## **WEST POINT PLAZA SUBDIVISION**

APPLICATION NUMBER 11 DATE July 17, 2014

REQUEST Subdivision

# DETAIL SITE PLAN

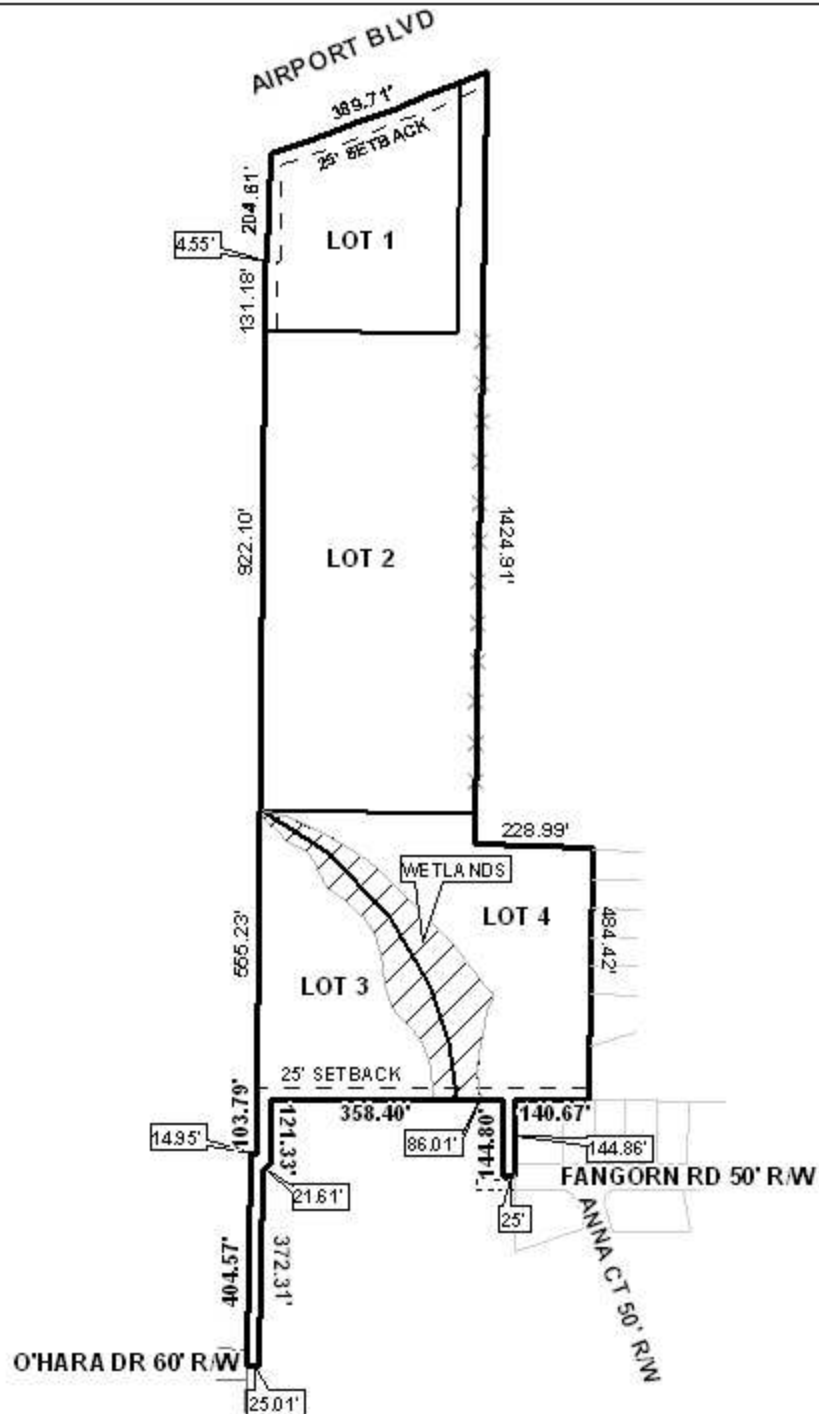
Proposed Lot 1 appears to meet the minimum size and frontage requirements of Section V.D.2. of the Subdivision Regulations. However, Lots 2, 3, and 4 do not comply with Section V.D.3. of the Subdivision Regulations regarding maximum depth. Thus, a waiver will be required in order to approve the subdivision as proposed.

Proposed Lots 2, 3 and 4 appear to be flag lots, and, while meeting the minimum width of 25 feet for a flag lot, the applicant did not provide any information stating unusual circumstances which may exist on the lots, or if there is a natural or pre-existing man-made barriers which may cause an undue hardship. Flag lots are generally not allowed, and there appears to be only one flag lot in the immediate vicinity of the site which was approved by Planning Commission in September 2001. However, the proposed lots do not appear to satisfy the requirements of Section V.D.1. of the Subdivision Regulations and no justification was provided.

Airport Boulevard, which is shown as a major street on the Major Street Plan component of the Comprehensive Plan, requires a minimum right-of-way of 100-feet. The preliminary plat does not depict a right-of-way width. Revisions should be made to note the right-of-way width of Airport Boulevard. The dedication of sufficient right-of-way along Airport Boulevard to provide 50' from centerline may be required; thus, revisions to the 25' minimum building setback line along Lot 1 would be required as well.

The site in question has been approved twice and received one extension for two separate subdivision applications; however, the perimeter of the previous subdivision request did not include any additional parcels or lots. The current subdivision application, as proposed, includes a portion of Barry Victor Subdivision Lot 1. It appears that the applicant is proposing to use a remaining portion of the lot from the Barry Victor Subdivision to serve as two separate access driveways that will connect Lots 3 and 4 to two existing roads. An easement and right-of-way deed was recorded on February 27, 2014 to allow the ingress and egress. As the site is within the planning jurisdiction the applicant must include the entire property on which the easements have been created, so that the easements may be shown on a recorded plat that includes the granting property. This application can not be considered because the adjacent remnant lot has not been included in the subdivision application. The applicant would have to revise the plat to eliminate the two access driveways that connect to the adjacent property or revise the plat to include the entire adjacent lot remnant that they are proposing to utilize as an access point for Lots 3 and 4.

The 25-foot minimum building setback is shown and labeled on the preliminary plat; however, the setback line for Lot 2 should be revised to illustrate it from where the pole meets the "flag". If approved, the minimum building setback should be illustrated on the Final Plat.

The lots are not labeled in acres or square feet. If approved, revisions should be made to depict the lot sizes in square feet and acres on the Final Plat, or a table should be furnished on the Final Plat providing the same information.

The plat illustrates wetlands on a portion of Lots 3 and 4. The presence of wetlands indicate that the area may be environmentally sensitive; therefore, the approval of all applicable federal, state and local agencies would be required prior to the signing of the Final Plat.

Lots 2, 3, and 4 are flag lots and if approved, a note should be placed on the Final Plat stating no future subdivision of Lots 2, 3, and 4 shall be allowed until adequate frontage is provided.

- 1) the proposed lots 2, 3 and 4 do not comply with Section V.D.3. of the Subdivision Regulations regarding maximum depth;
- 2) the proposed lots 2, 3, and 4 do not comply with Section V.D.1. of the Subdivision Regulations regarding size and shape of lots, and no justification has been provided; and
- 3) the applicant has failed to include the adjacent property owner’s remnant lot with the subdivision application, as is necessary to establish the easement.
